**ADDENDUM NO. 2**

**PROJECT NAME:** UNL Devaney Sports Center Improvements  
**UNL PROJECT NUMBER:** C100P098

**DATE OF ISSUANCE:** Friday, April 6, 2012

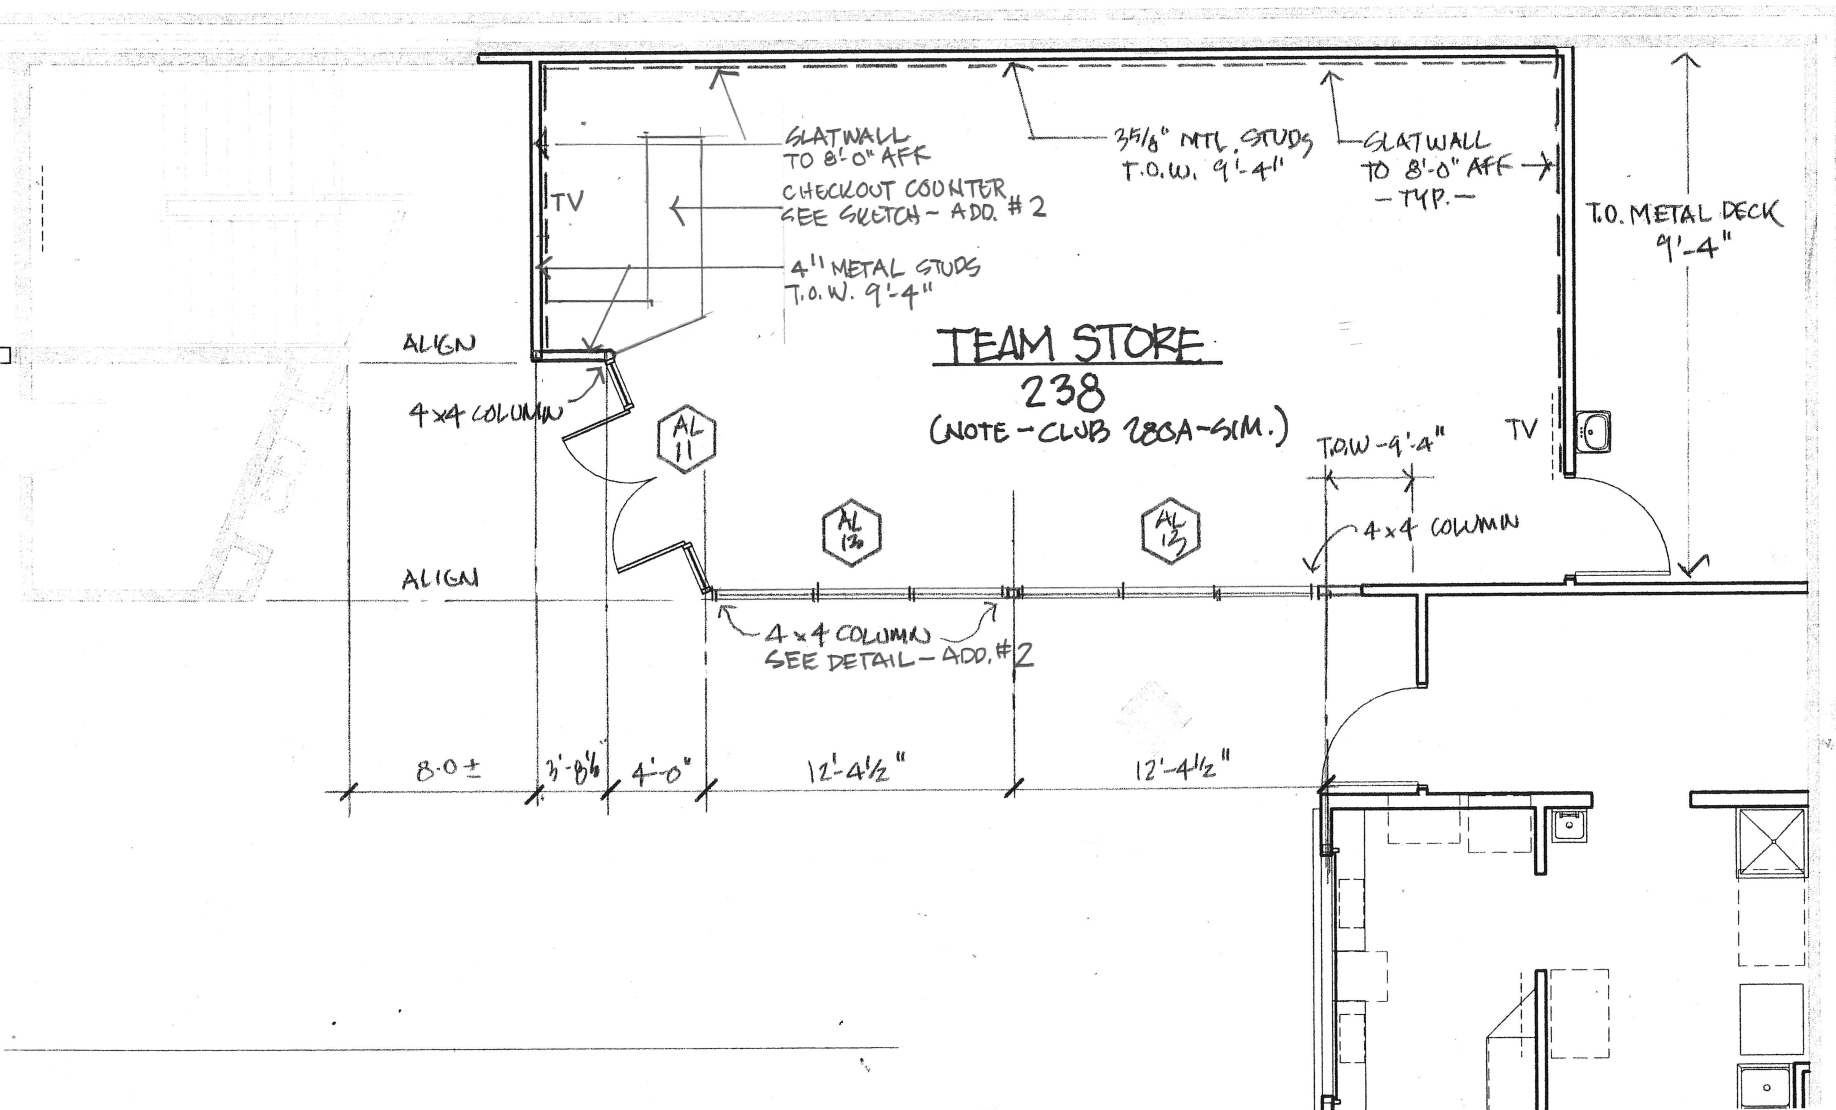
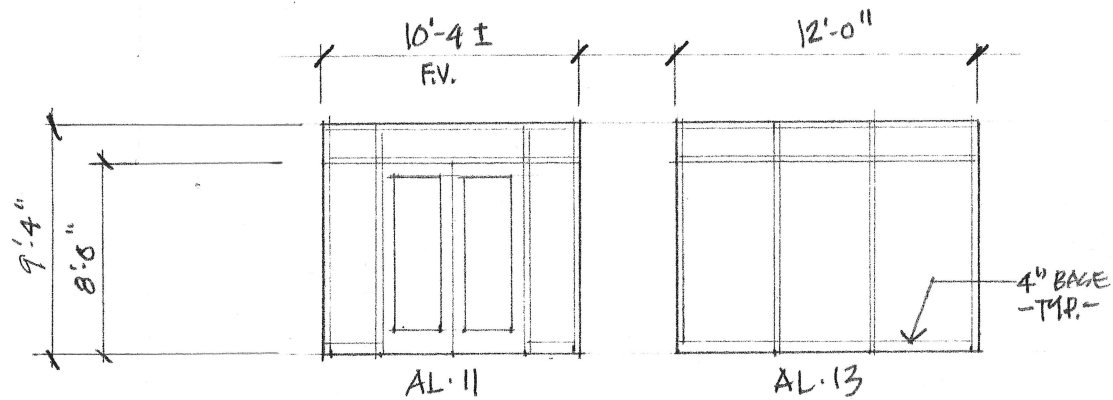
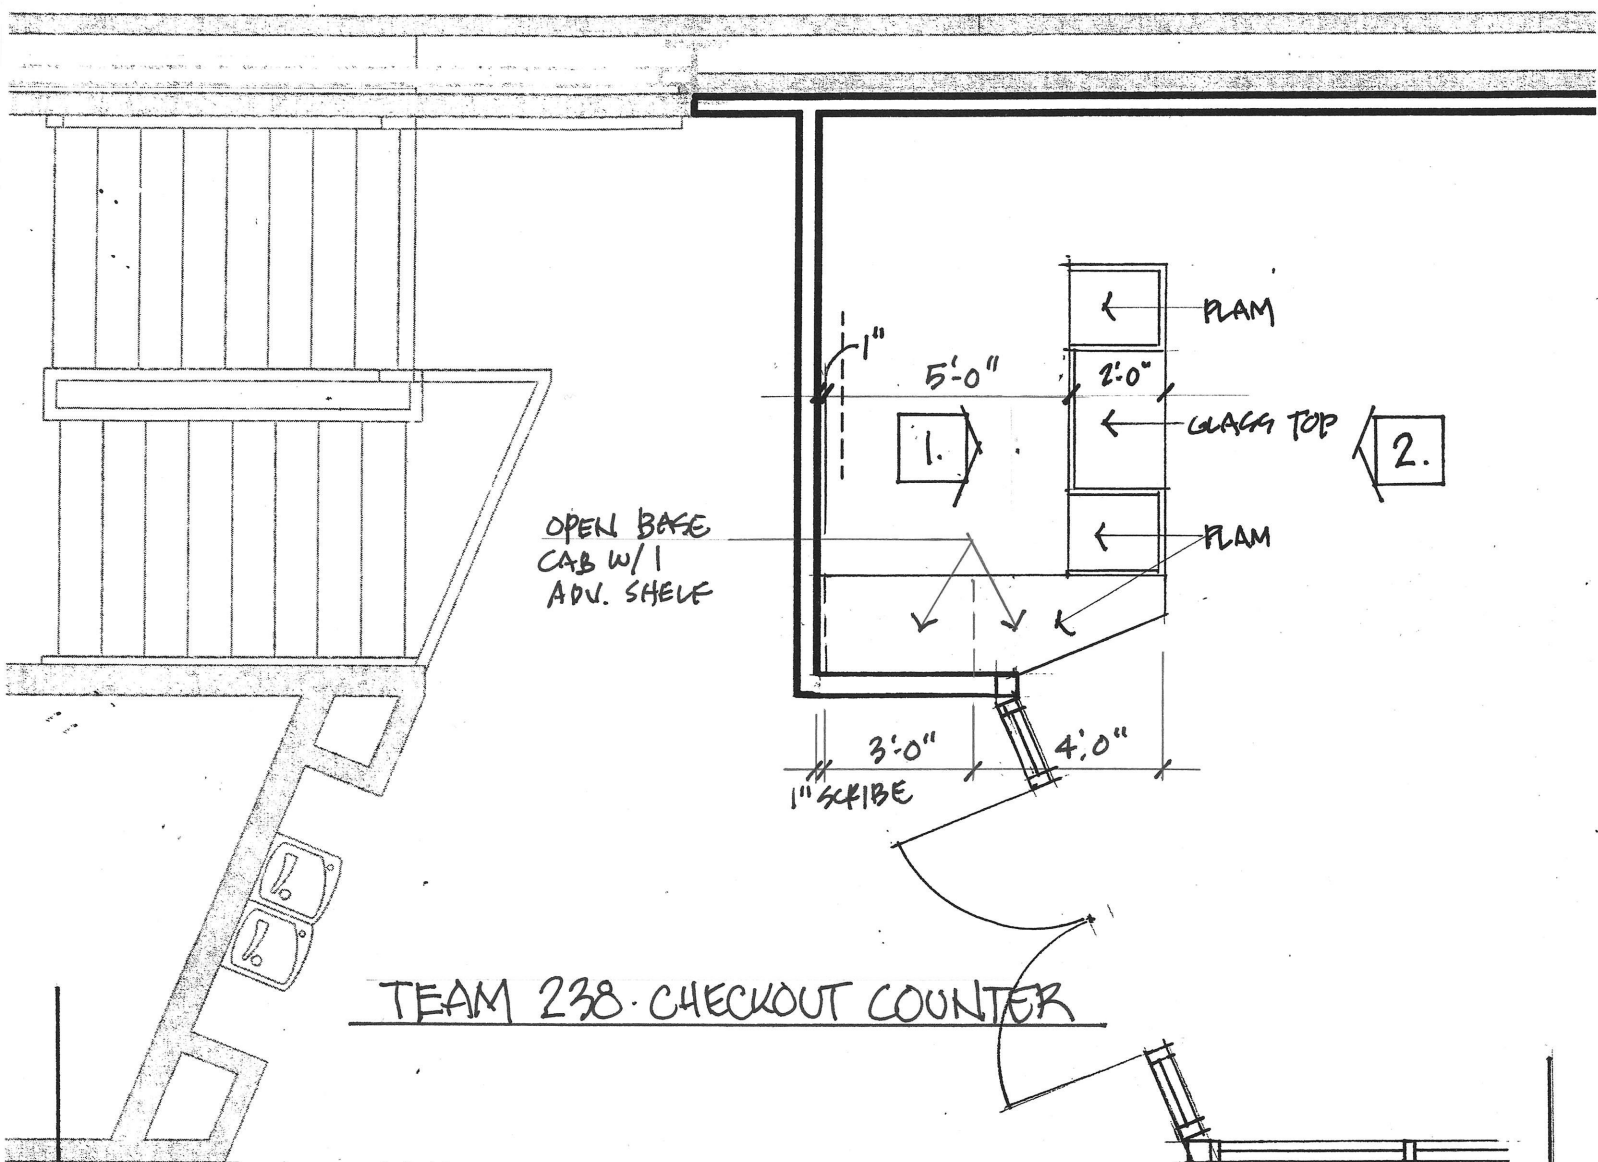
1. At Team Store 238, see the attached plan for the aluminum storefront enclosure at this space and the aluminum storefront elevations. (See Attachment)

2. At Team Store 238, provide Slatwall on the north, east, and west walls as indicated on the attached sketch. (See Attachment) Slatwall shall be 3/4" thick MDF grooved to receive standard size fixture mounting brackets as manufactured by Slatwall Systems or an equivalent product. The panel finish shall be select white maple with a factory applied clear finish. Grooves shall be T-shaped spaced at 3 inches on center with natural fiberboard finish in the grooves.

TEAM 238 - CHECKOUT COUNTER

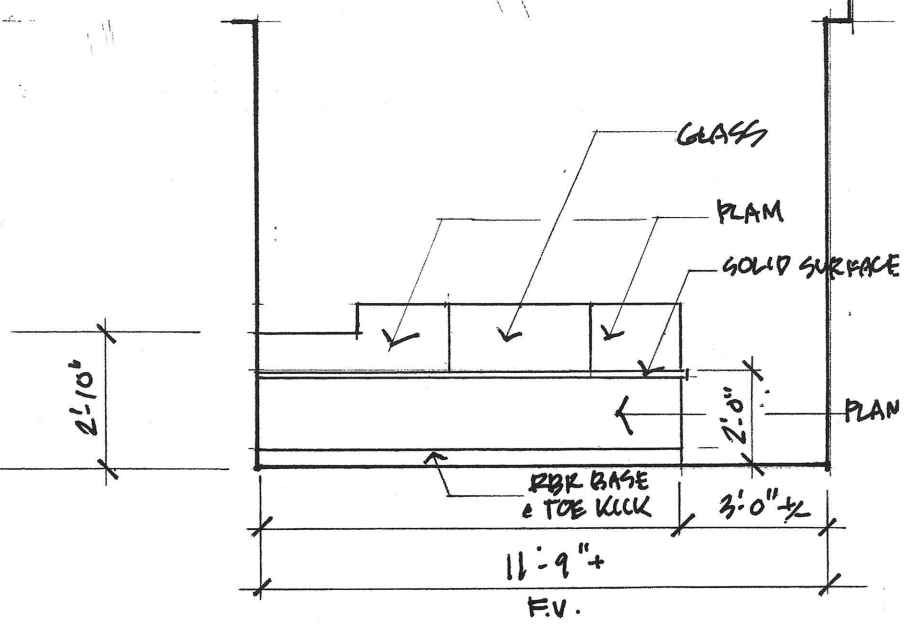
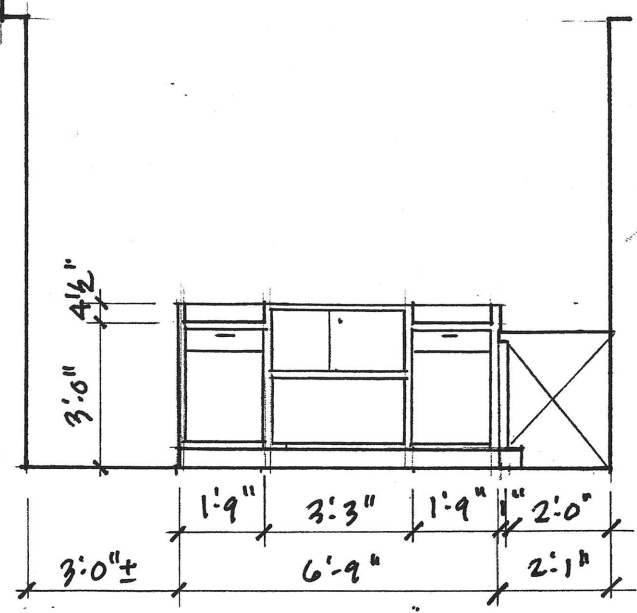
3. At Team Store 238, add the check-out counter millwork as indicated in the attached sketch. (See Attachment)
4. See the attached sketch for the steel tube support columns at the aluminum enclosure walls at Team Store 238, Club 218, and Club 280A. The steel tubes are to either be concealed in gypsum board wall or covered with aluminum brake metal to match the storefront framing.

CLUB 218

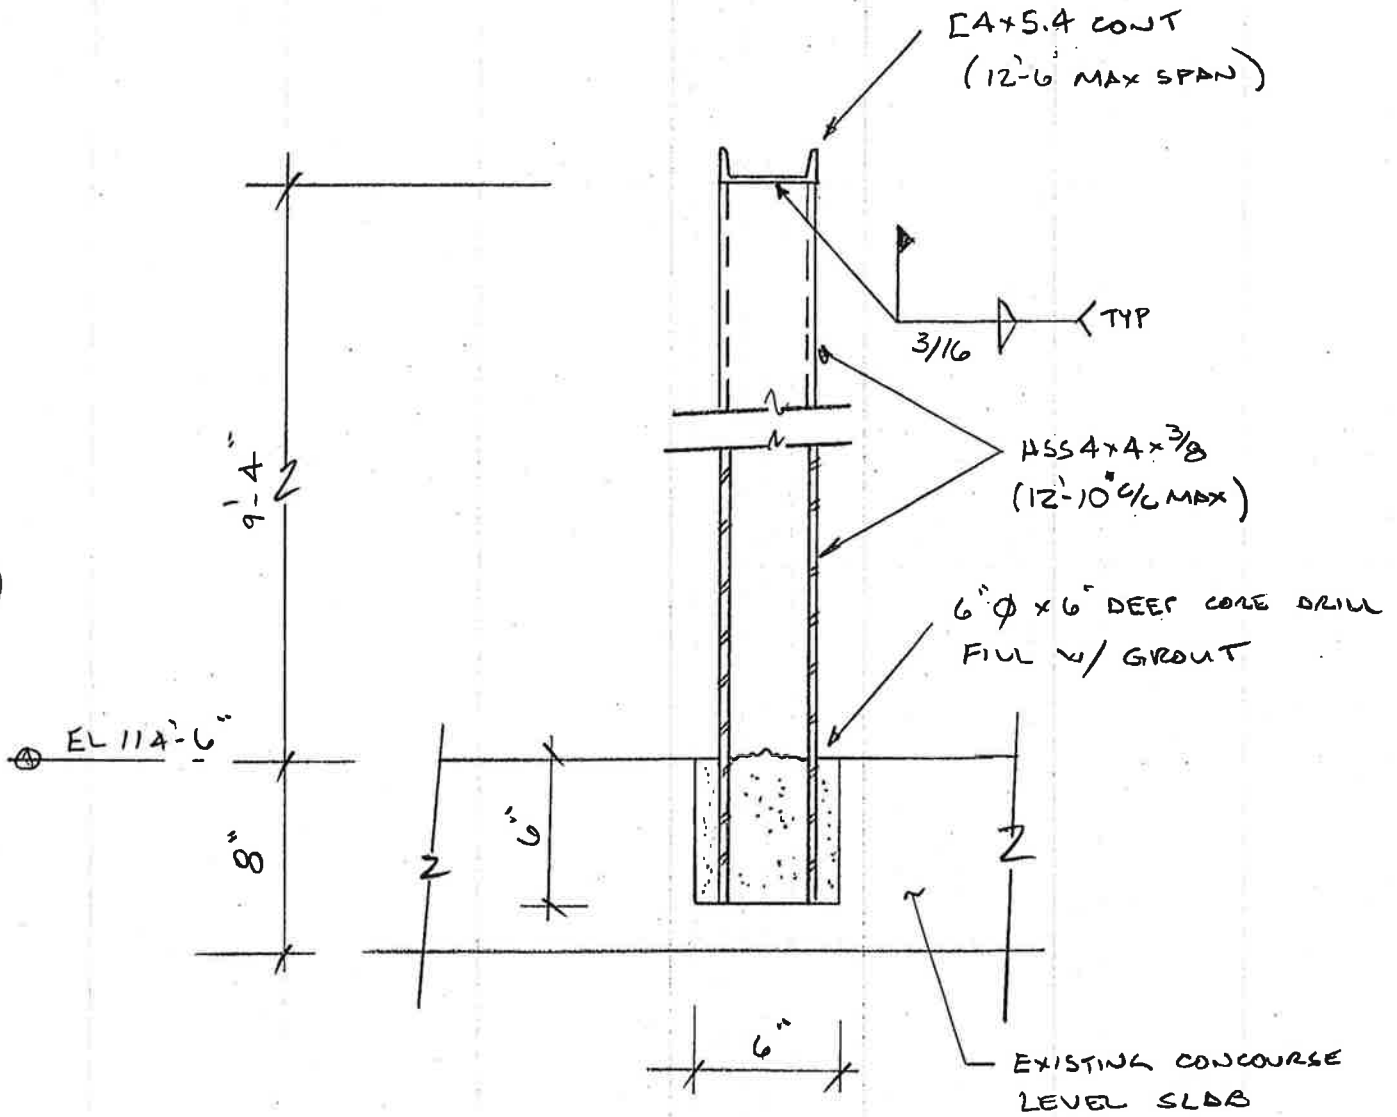
1. At Club 218, see the attached plan for the aluminum storefront enclosure at this space and the aluminum storefront elevations. Note that the configuration has been modified to mirror Team Store 238. The layout at Club 218 uses aluminum storefront assemblies to the extent indicated. The frame at the entry door reuses the existing doors and framing pieces—modified as needed. The existing storefront is to be removed and salvaged as per Note 8F on Sheet A001.B. (See Attached Plan)
2. At Club 280A, modify the aluminum storefront enclosure to mirror the enclosure at Team 238 (see item above). (See Attachment). Add the furred gypsum assembly at the south

DEVANEY SPORTS CENTER  
 ARENA LEVEL PLAN -  
 AREA 'A' - DEMOLITION

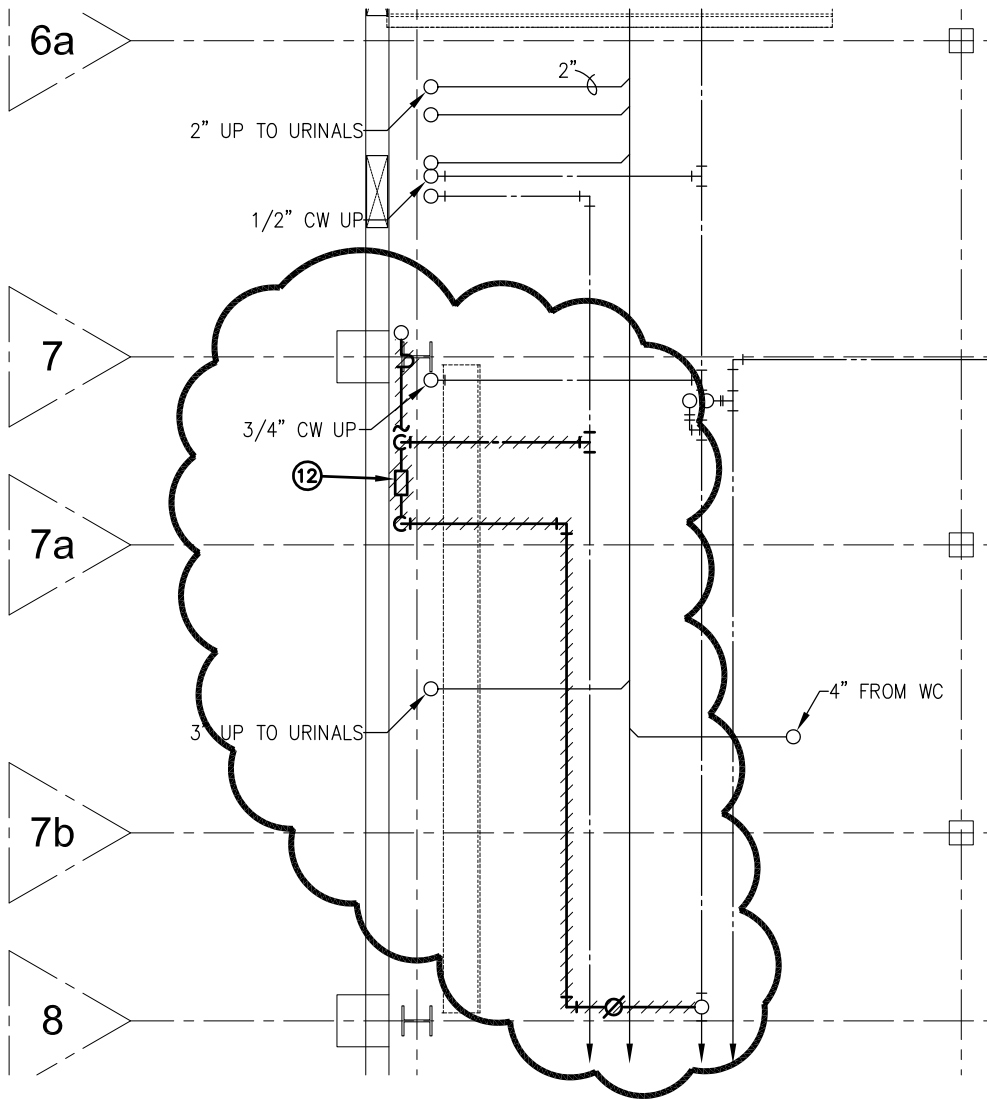
1. Sheet M600 - Mechanical Schedules
  - A. P-11, 12, 13, 14, 18, 19, 20, 21 Contractor shall verify exact pump dimensions for substitute pumps to fit on existing pads and mate up to existing piping.
2. Sheet M401 – Enlarged Mechanical Room 138 - Mechanical
  - A. Note 20 discusses the relocation of the lawn sprinkler backflow preventer and reconnection to the existing system. The Contractor shall be responsible for any exterior changes required for reconnection. The Contractor shall also be responsible for disconnecting, repairing, and reconnecting any exterior system piping that exists in the staging areas or other areas which are disturbed due to construction.
3. Sheet M100.A – Arena Level Plan Area ‘A’ – Mechanical Demolition
  - A. Remove and relocate existing backflow preventer to mechanical chase on concourse level. See attachments 1M, 2M, and 3M.

12. REMOVE AND RELOCATE BACKFLOW PREVENTER. REMOVE PIPING TO LOCATION SHOWN AND CAP.

SHEET  
**M201.A**  
 ATTACHMENT NO.

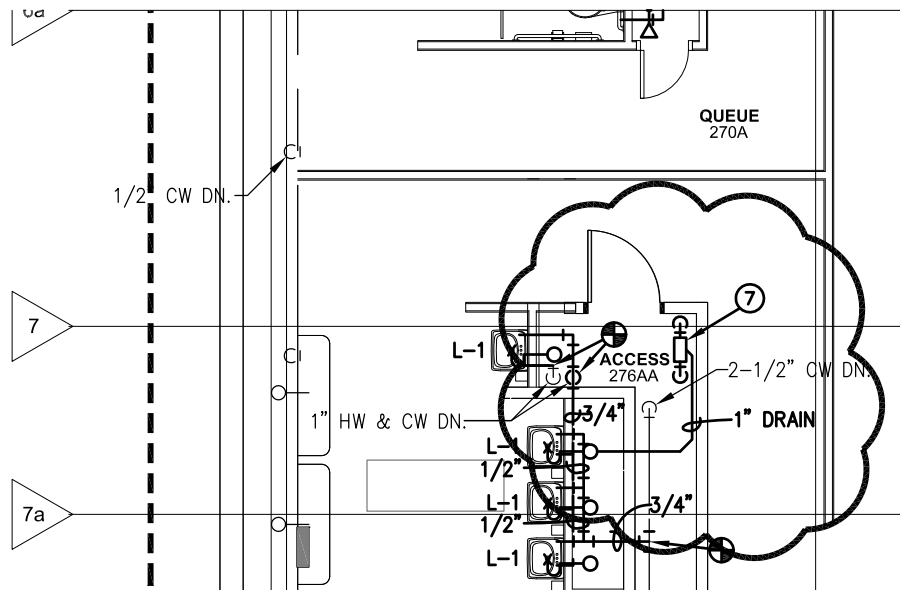
- 7. RELOCATED BACKFLOW PREVENTER.
